STAFF REPORT AND DECISION

File Number: SDR 2025-01

Request: Site Development Review of a 5-story hotel with 96 rooms, 105,000 gross square

TEMPORARY PARKING PLAN

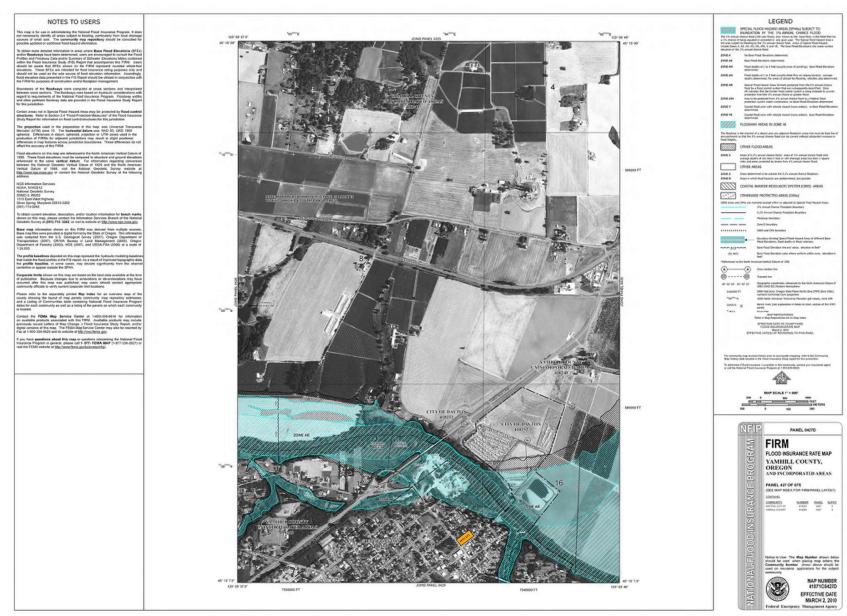
Finding: The submitted parking plan to develop the remainder of the applicant's property in the CBO with surface parking lots is described as a temporary plan, but the application does not include any information about what a permanent parking plan might be. The application provides no basis for reviewing a permanent parking plan for compliance with the applicable development standards for off-street parking and loading. The majority of the project, measured in area, involves parking. Because parking is not permitted as a standalone use in the CBO, the parking areas can only be permitted as an accessory use to the hotel site. Therefore, if the applicant does bring a permanent plan forward in the future, this decision will need to be modified with another Site Development Review application which is included as a condition of approval.

The submitted parking plan to develop the remainder of the applicant's property in the CBO with surface parking lots is described as a temporary plan, but the application does not include any information about what permanent parking plan will be. Further, contract planning staff are unable to find any precedent for a similar project that uses a parking program that relies on a valet to service remote off-site lots. Therefore, all the issues enumerated above remain unresolved, and the temporary plan presents adverse impacts of its own.

STEP BACK DIAGRAM

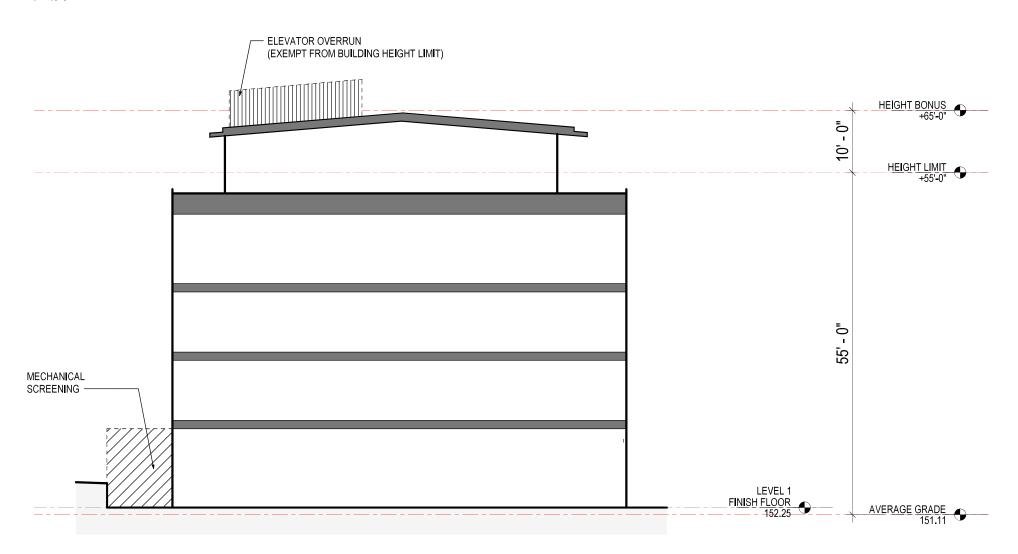
The walls of the building on Level 5 step back from the building plane of the ground floor by at least 10'-0". However, the step-back includes a roof eave. The eave occurs on the north, east and west elevations. Please reference Exhibit 3.16 illustrating this.

South Building Elevation

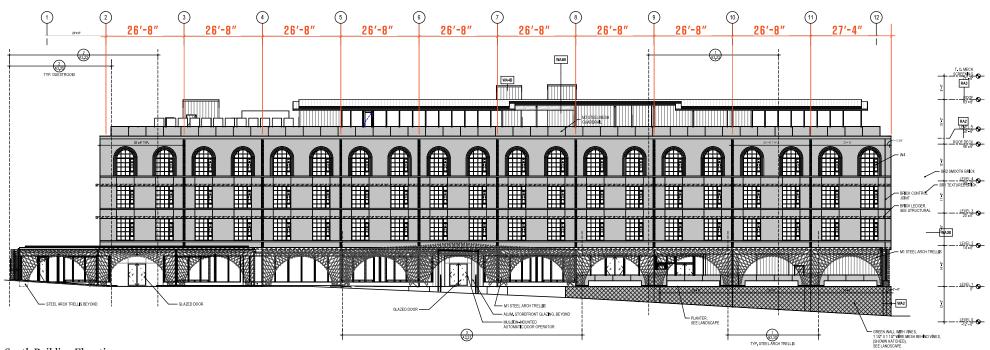
Finding: The most conspicuous feature of southern elevation facing Ferry Street is a flat façade, 267 feet wide, and three stories high that is lacking in offsets, recesses, projections, or breaks in wall plane. While this is an example of the kind of undesirable feature of large format commercial buildings that the standard is intended to prevent, as explained in Section II, the standard was adopted to:
